Spring Farm Play Space

**PUBLIC
CONSULTATION**

Plan for Spring Farm Play Space

11. KERBING FOR BETTER ACCESSIBILITY

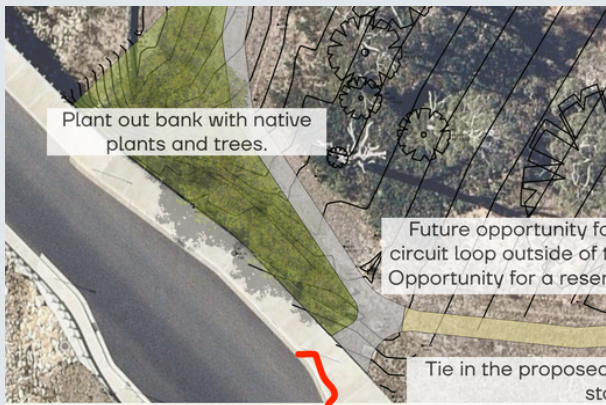
To make playground more accessible and to create a pedestrian island to slow down traffic in the area (see picture below).

Council's Roads Engineer will consider the issue of kerb ramps and pedestrian islands.
